Response to: Consultation on Cobden Junction

I am writing on behalf of Camden Cycling Campaign, the local borough group of London Cycling Campaign. We have over 600 members and represent the interests of cyclists living or working in the borough of Camden. We consulted our members by email and on CycleScape about the Cobden Junction consultation and this response has been agreed by the committee and reflects the views of the membership.

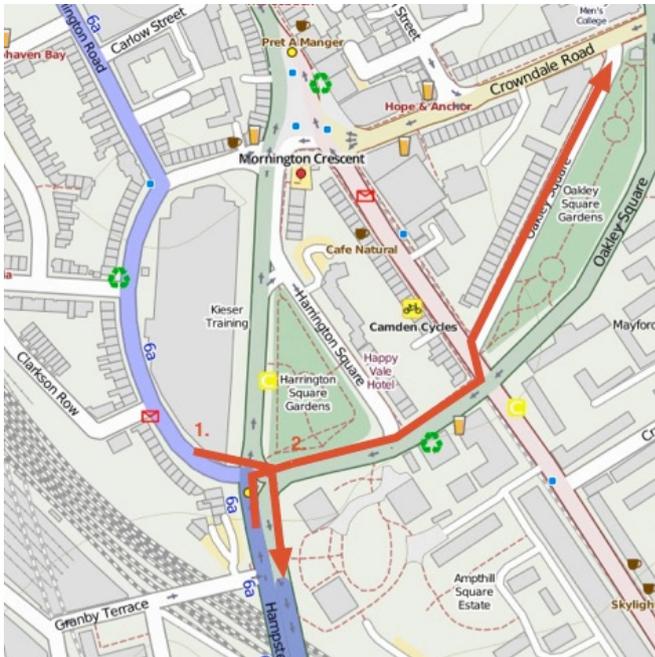
The quiet route labelled 6a on the map requires a right turn into Hampstead Road (red arrow 1). Note that the need for this turn was identified in the CRISP Report on Link 27 (CCS 2007). This should be included in the design of the link on red arrow 2.

This link is important for the canal alternative route as well as being the most central one across Camden Town and would be a great addition to cycling permeability.

This link should not be forgotten. It links well with quiet route 6a and a contraflow

has already been built in Plender Street. It could be an opportunity to improve Miller Street. One member has suggested that since the council owns the disused land behind the railings, it would be of great community benefit if it was used to create a quality bike route.
